MEMO

To: Kristopher Byrd, Well Construction and Compliance Section Manager
From: Joel Jeffery, Well Construction Program Coordinator
Subject: Review of Water Right Application G-18596
Date: August 8, 2018

Groundwater Application Review Summary Form

Application # G- 18596

Water-Level Trends in Nearby Wells

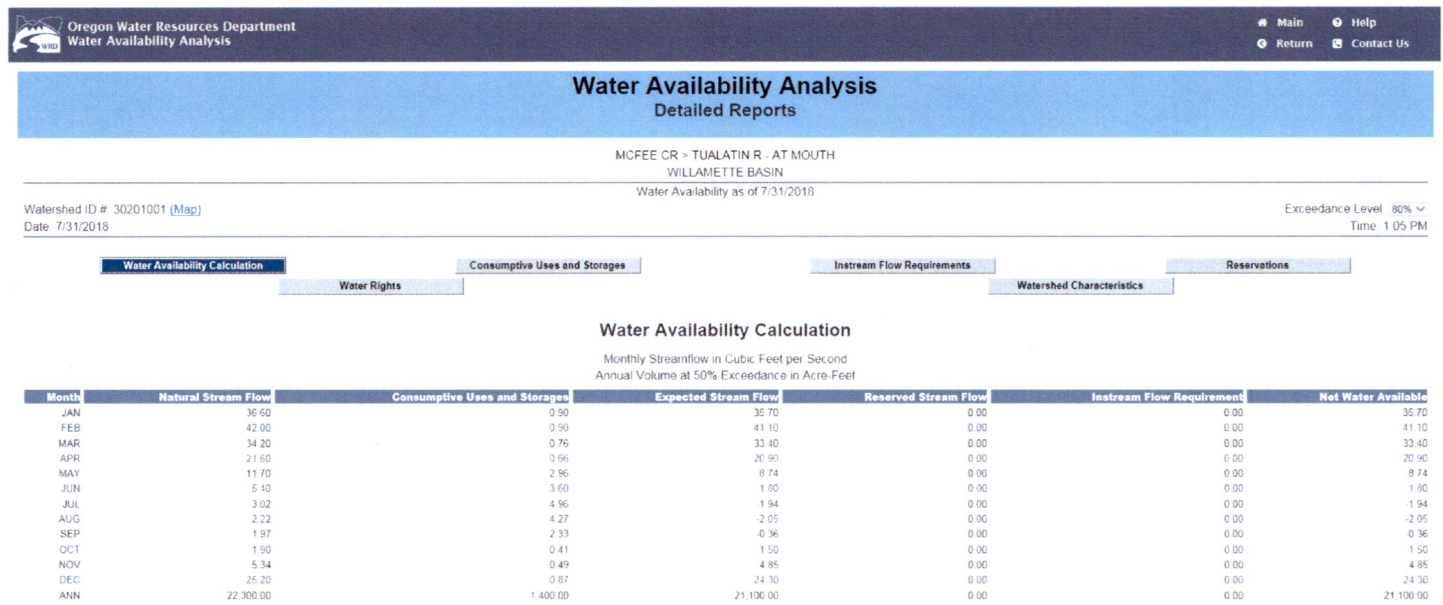
Groundwater elevations in the area suggest the water-bearing zone(s) in the applicant’s well may be shared by other groundwater users (see attached hydrograph). Long-term trends indicate relatively stable water levels in the area, with no significant losses in head within the CRBG aquifers at the current level of use. However, the typically low storativity of CRBG aquifers limit their potential productivity, both in rate and total volume and the long-term duration of sustainable use.

To protect existing users, water use reporting and water level monitoring conditions are recommended.
